AGREEMENT

WHEREAS, the CRA desires to retain the services of the Contractor to provide the goods and services in accordance with the CRA’s Invitation to Bid No. 2022-01-R, and the Contractor’s response thereto, all of which are incorporated herein by reference.

Sheet Title:
 FOUNDATION LAYOUT

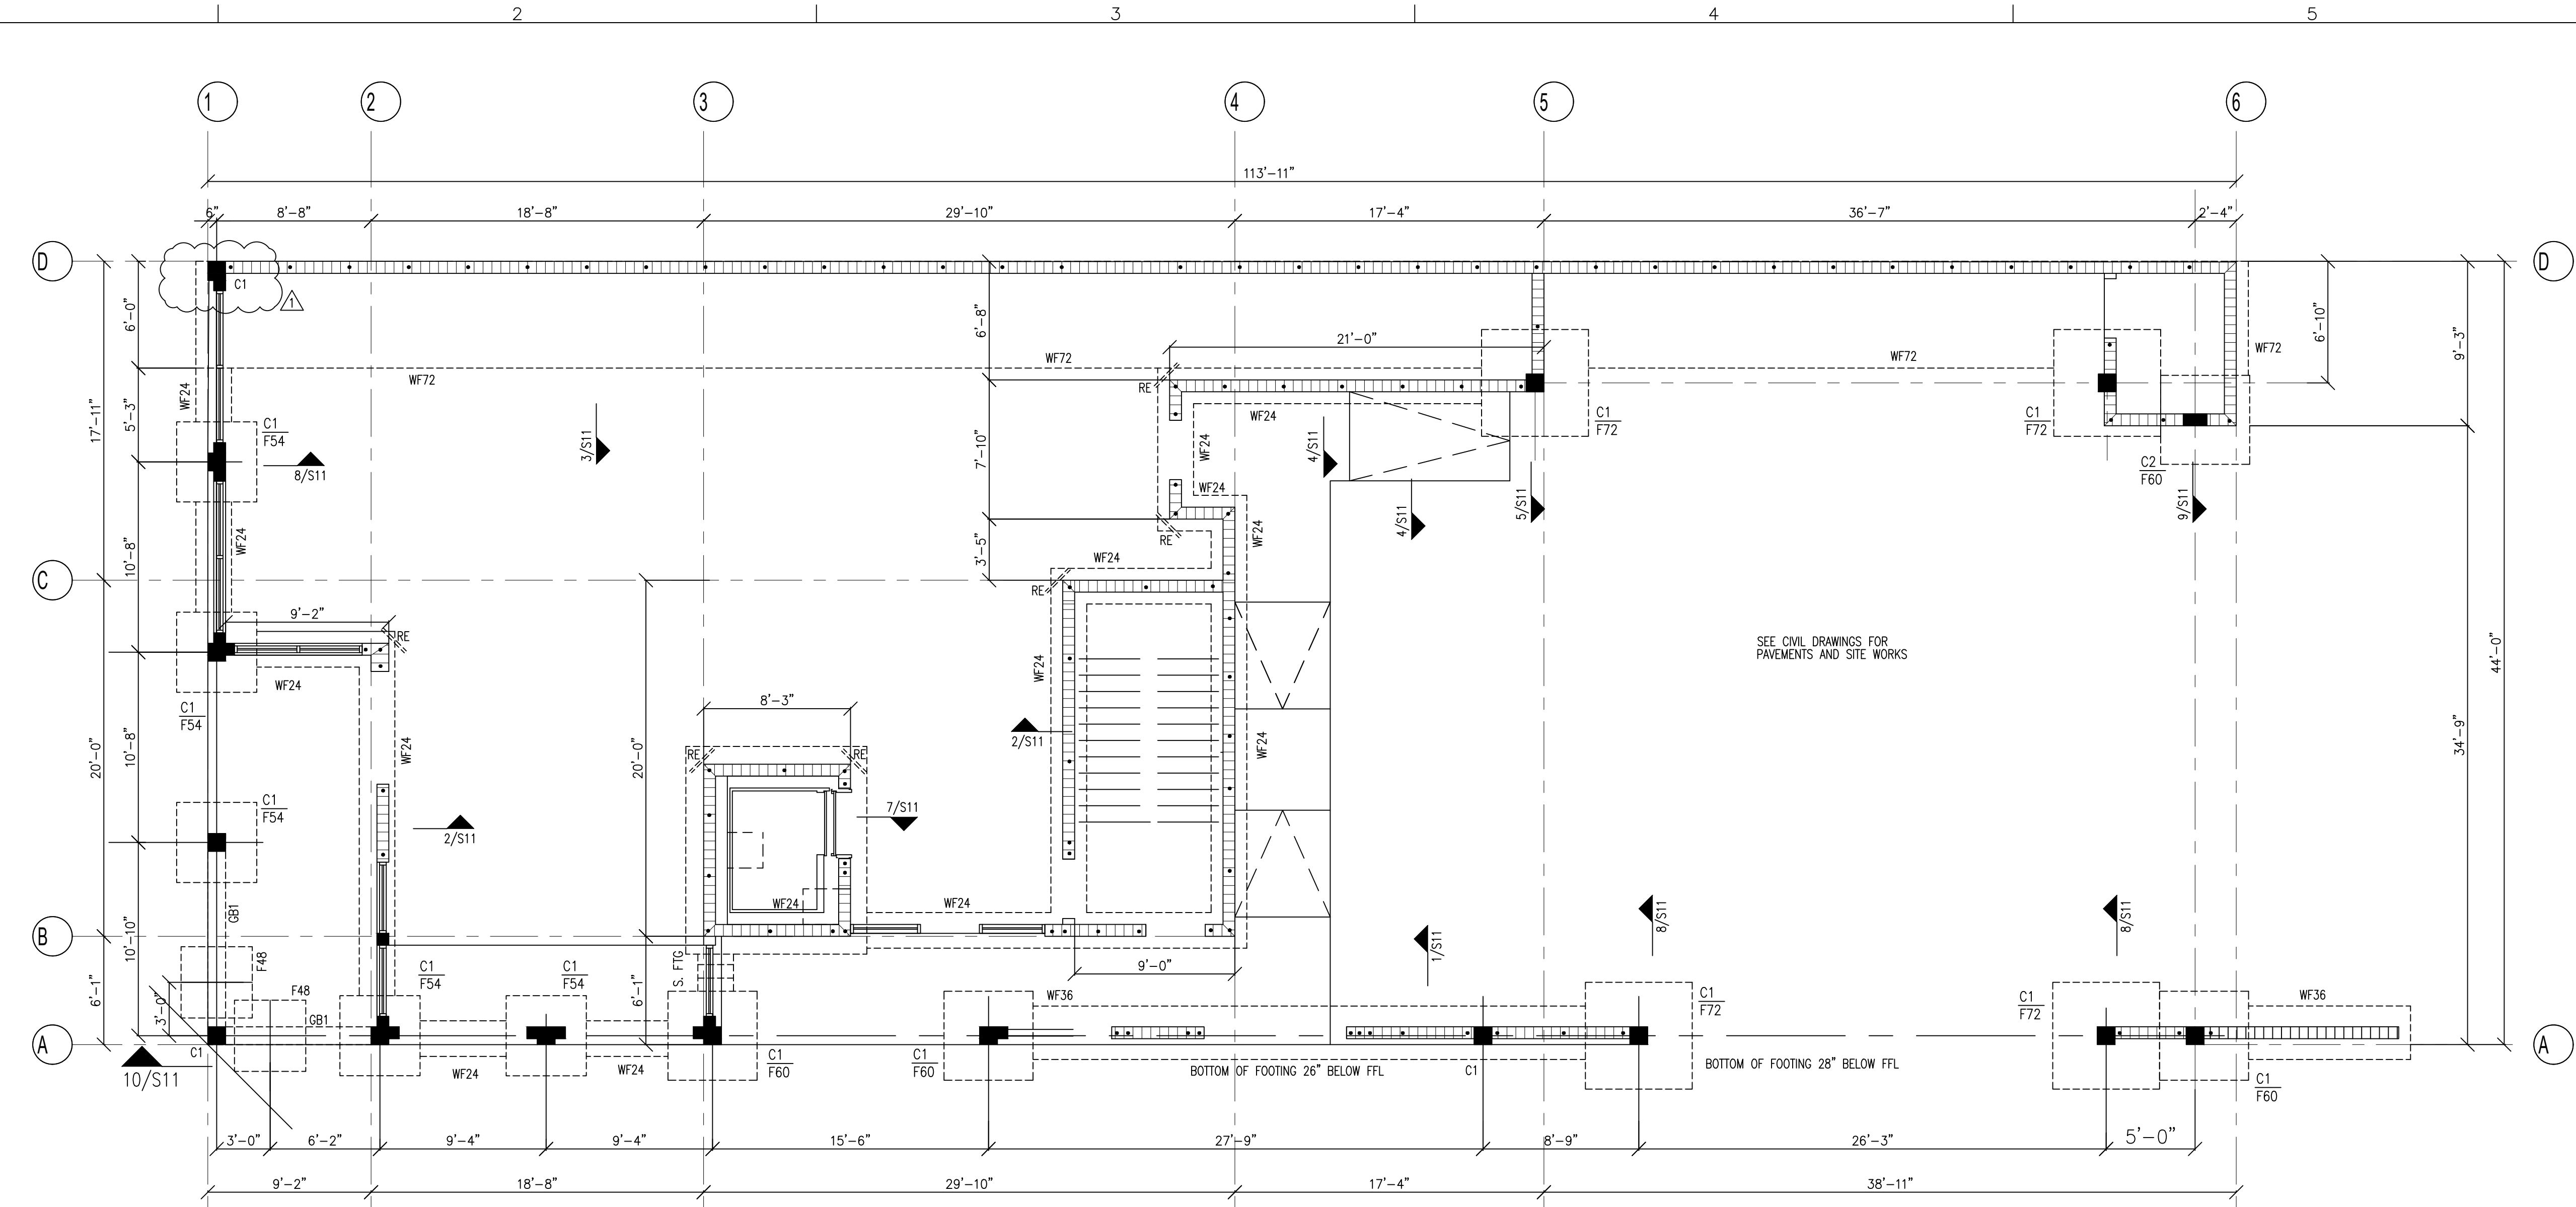
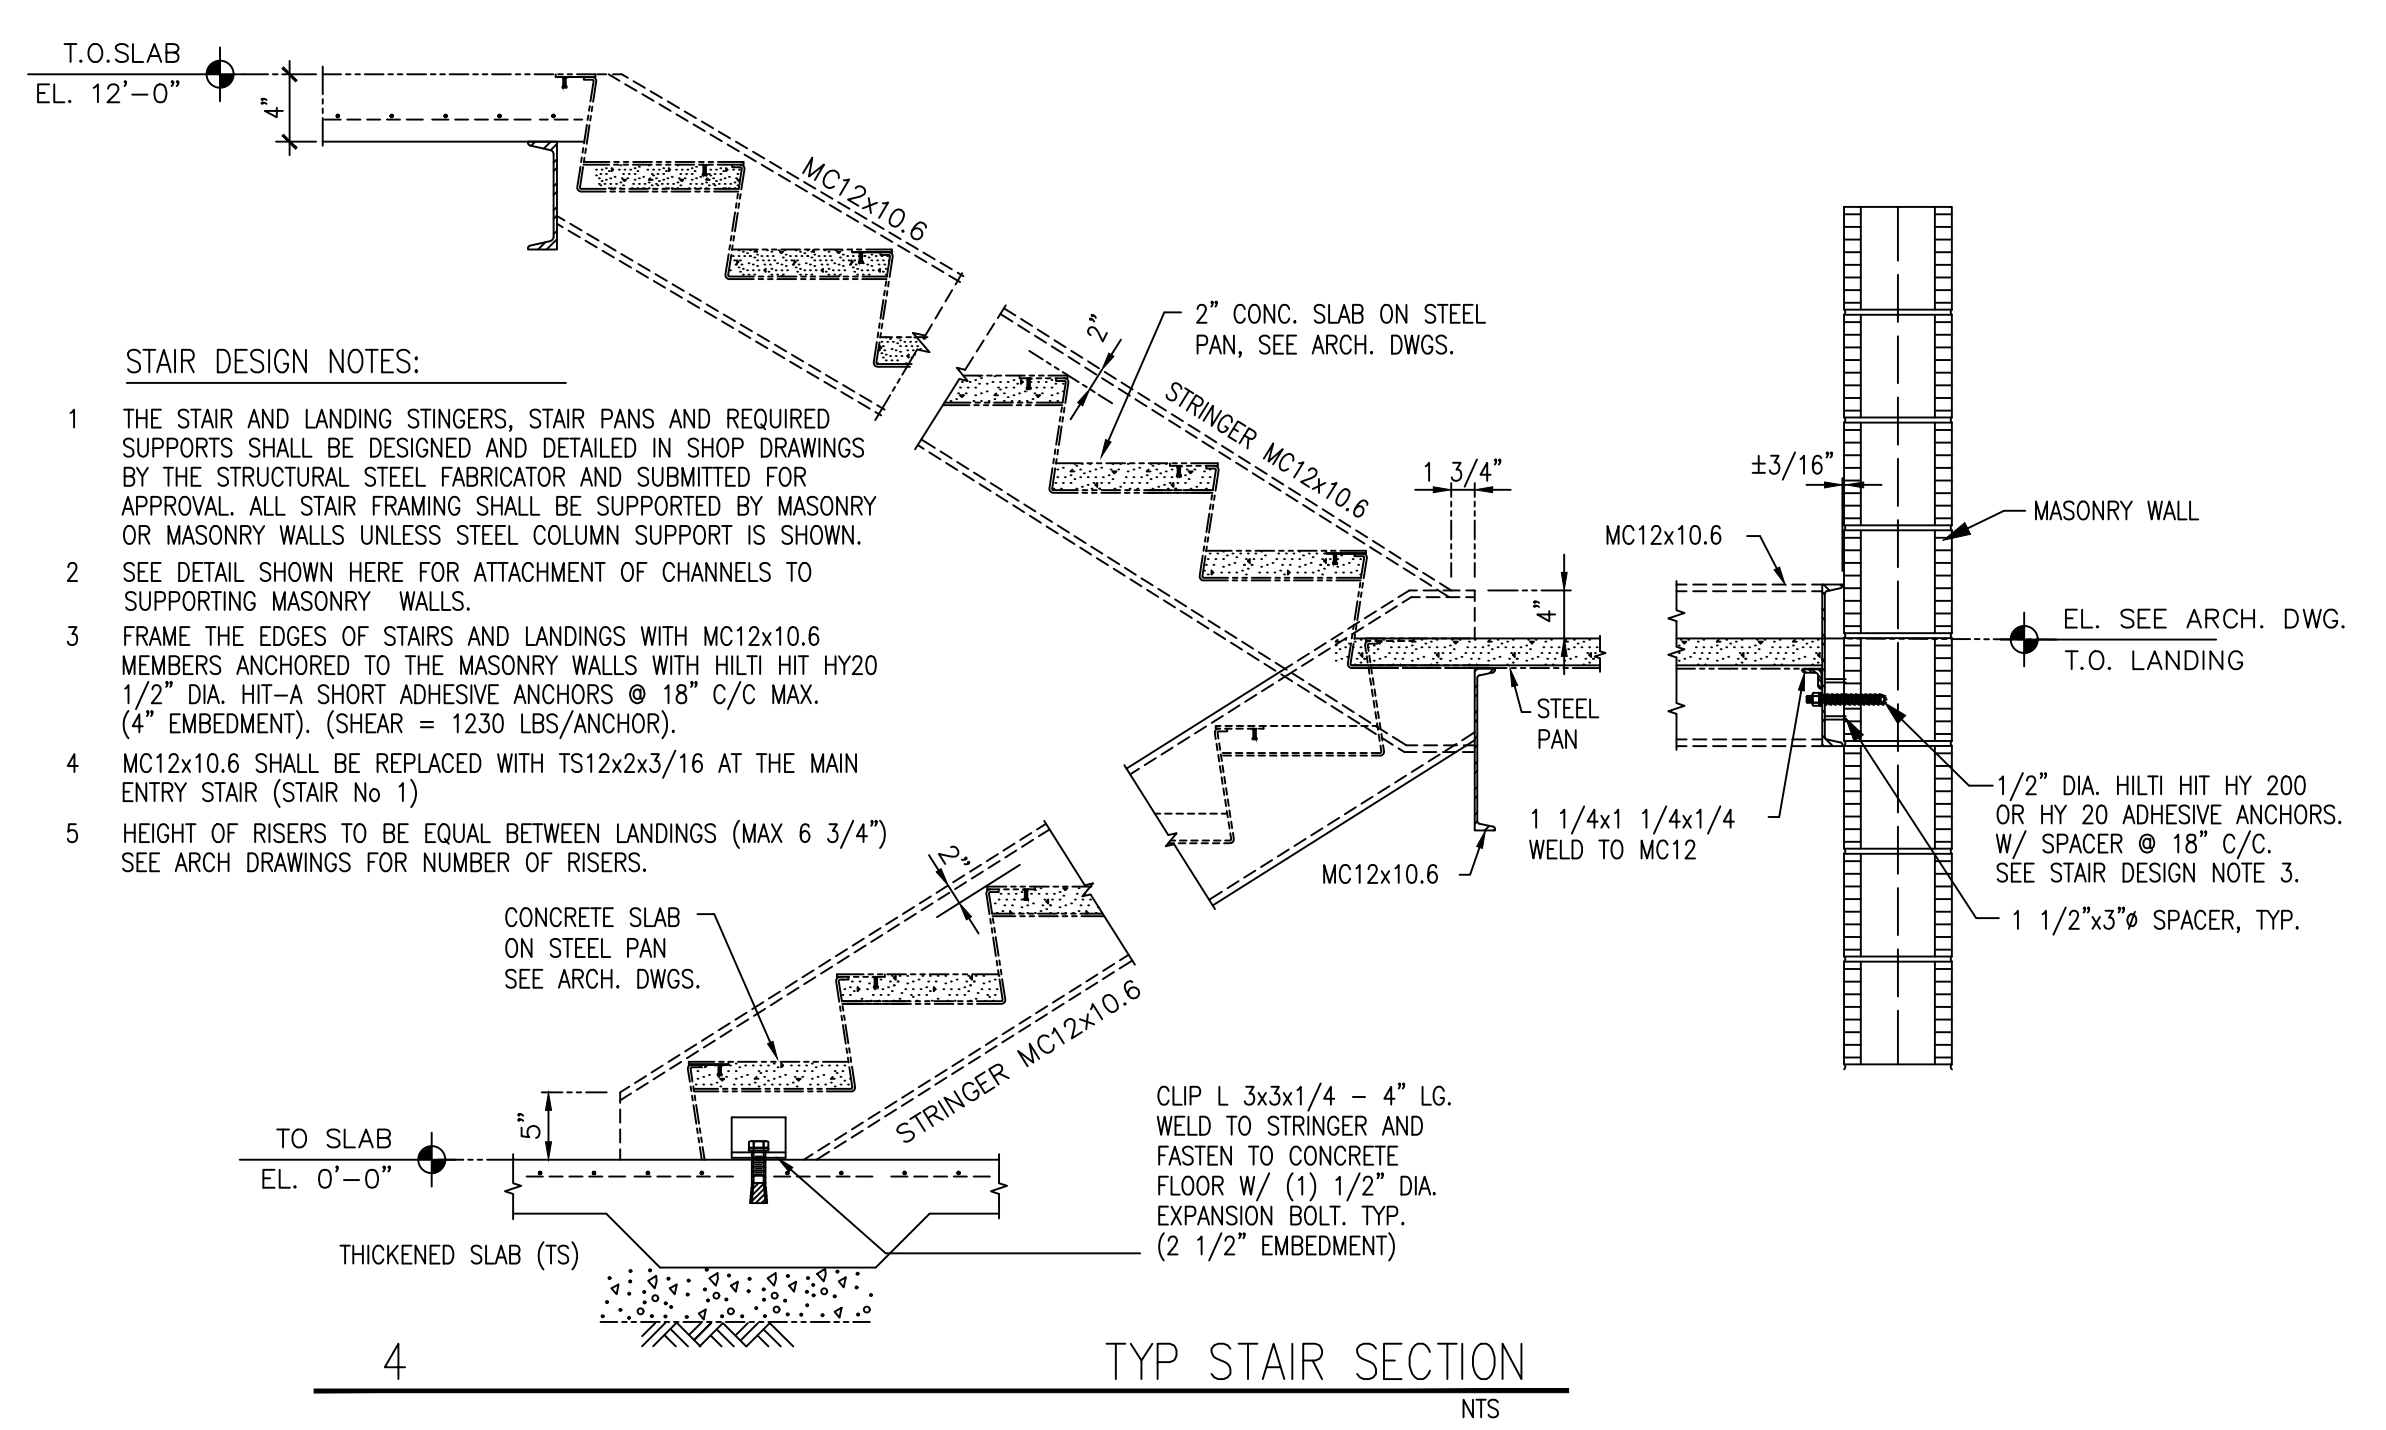
18. **F36 shows on the spread footing schedule, but it is not show on the floor plan (Drawing S10), please clarify.**

19. **C1 square appearance on the floor plan does not match with the square appearance of the column schedule (Drawing S10) , please clarify.**

20. **Two columns do not have marks (Drawing S10). Please clarify.**

F36 not used in the project. Drawing S10 is attached to this Addendum.

C1 is a square column sometimes with poured wall attached. Drawing S10 is attached to this Addendum.

C1 at grid line 1D, wall at grid line 2B. Drawing S10 is attached to this Addendum.

S20

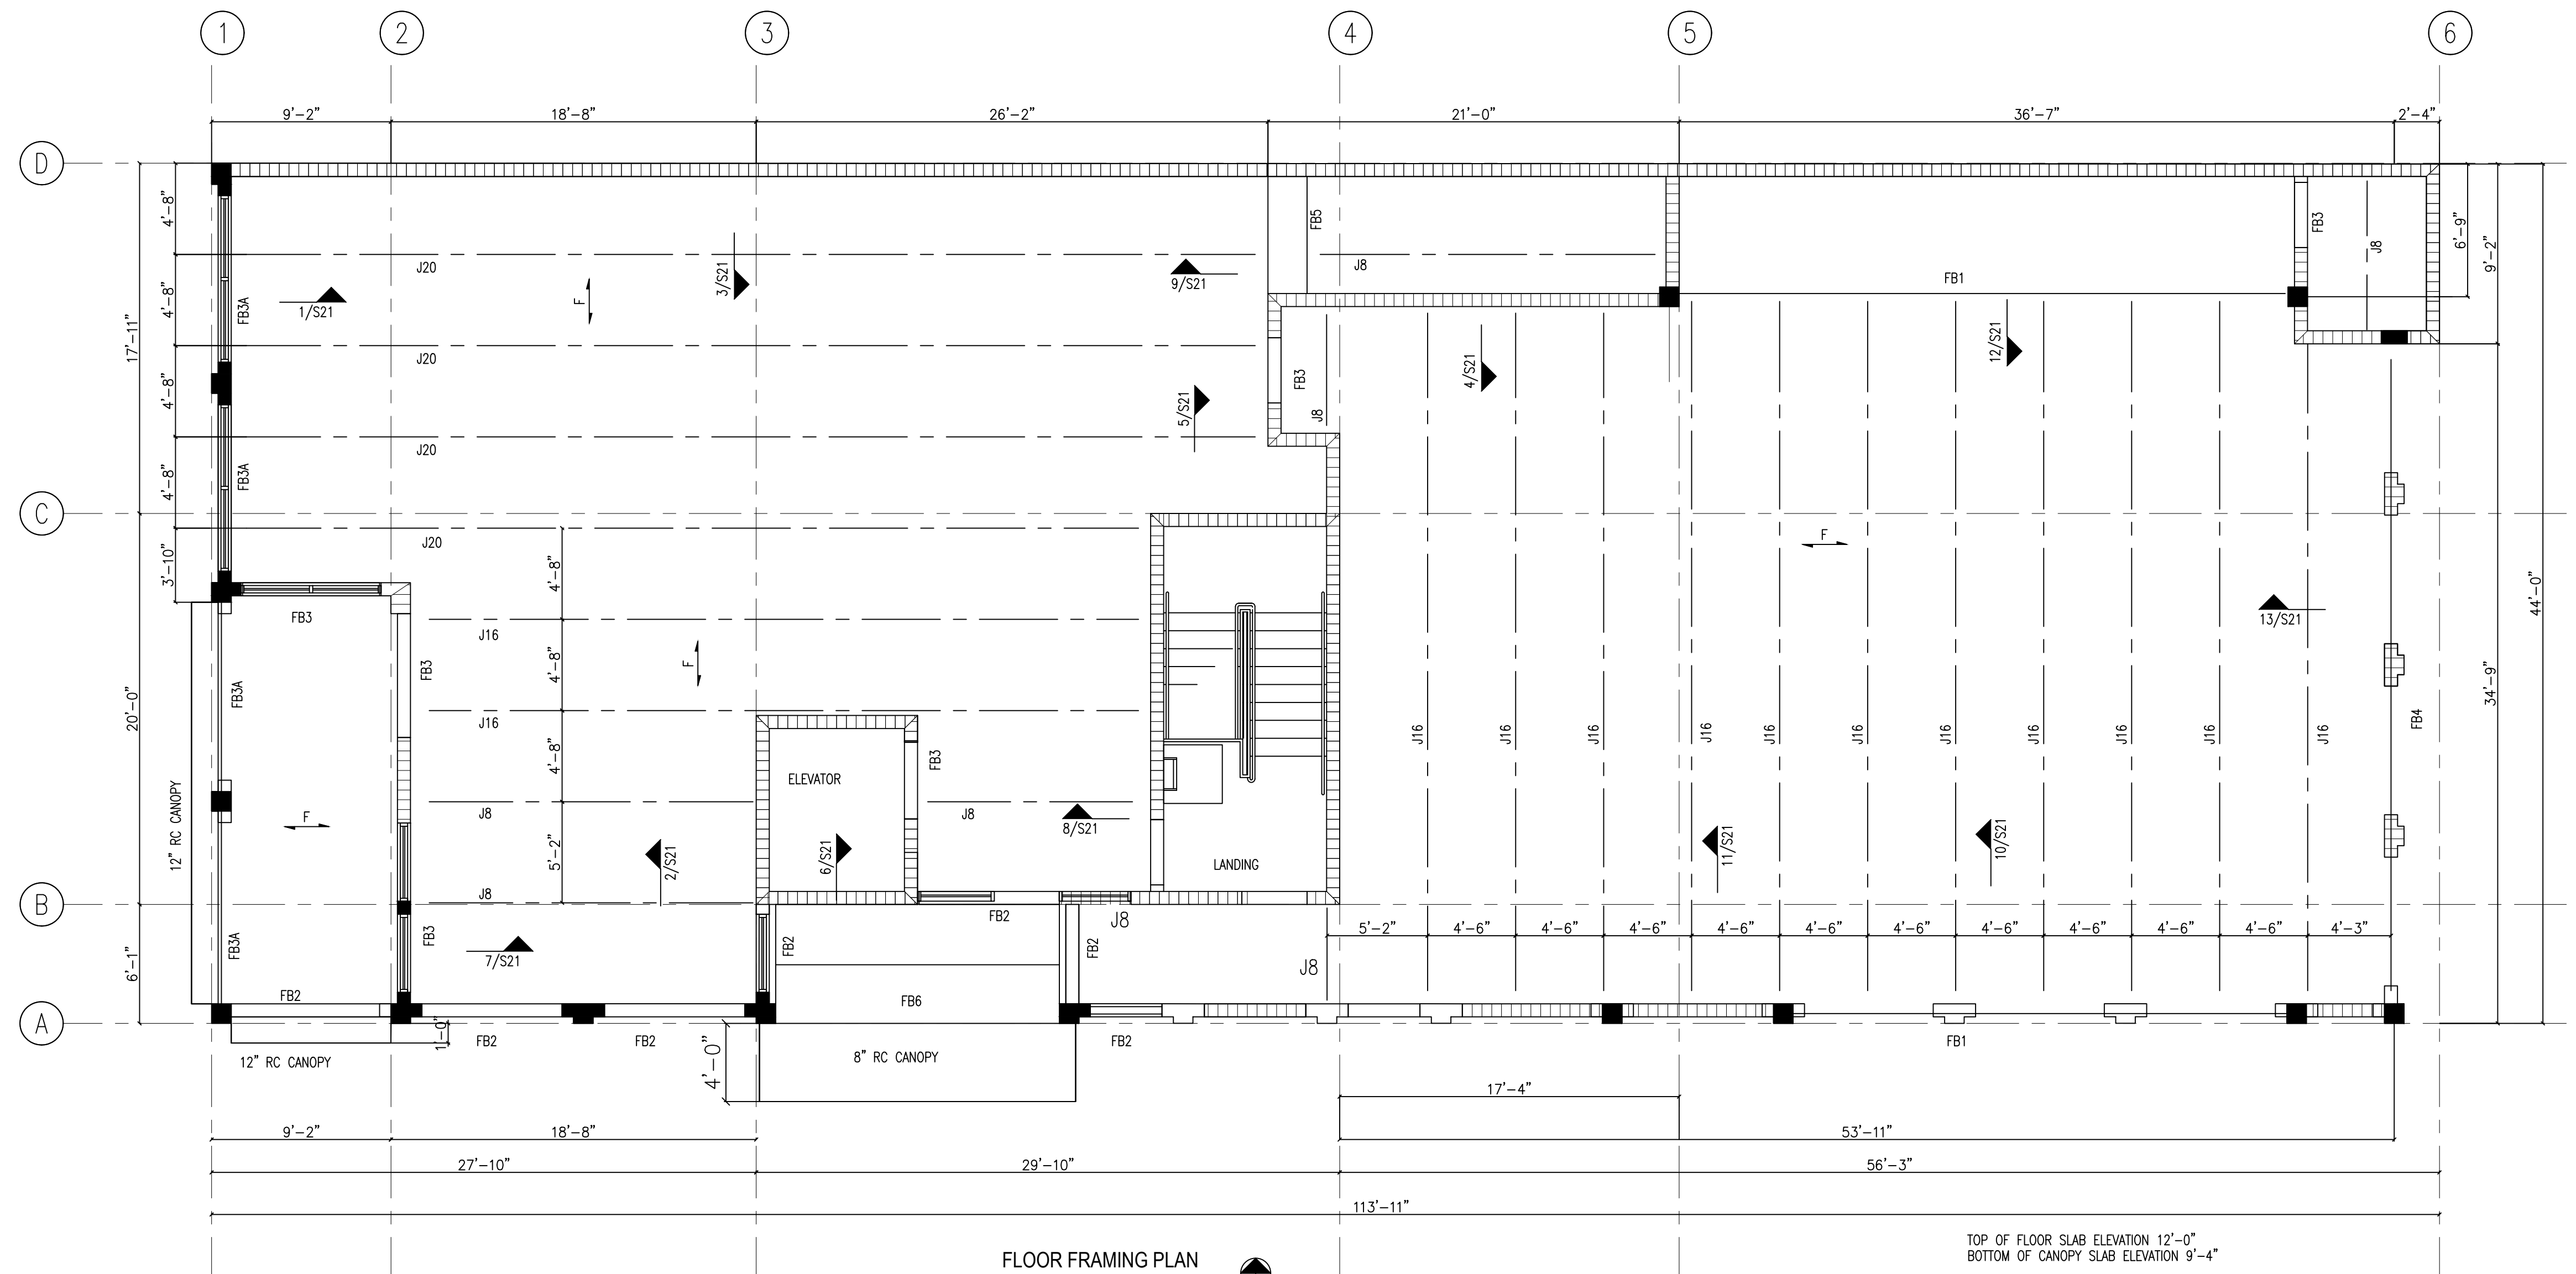
17. **FB1A shows on concrete beam schedule, but it does not show on the floor plan (Drawing S20), please clarify.**

23. **Drawing S20 does not show what kind of beam goes by schedule or will it be considered a couple bond beam. Please clarify.**

FB1A not used in the project. Drawing S20 is attached to this Addendum.

Use double bond beam unless FB shows on wall. Drawing S20 is attached to this Addendum.
